Subject: ESDI Document X3T9.3/87-005

The following is a copy of the letter received from Tom Wicklund of Ciprico which contains his list of recommendations to Rev 1.3.

Comments on Revision 1.3 of the ESDI standard:

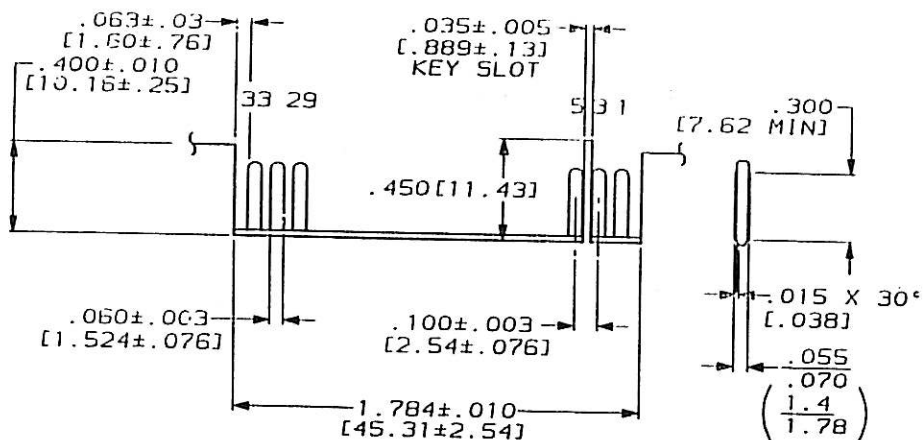
Appendix A, fifth paragraph, the initial word "The" should be removed, so the sentence reads:

"Sector 0 of each surface will contain the defects for that surface only."
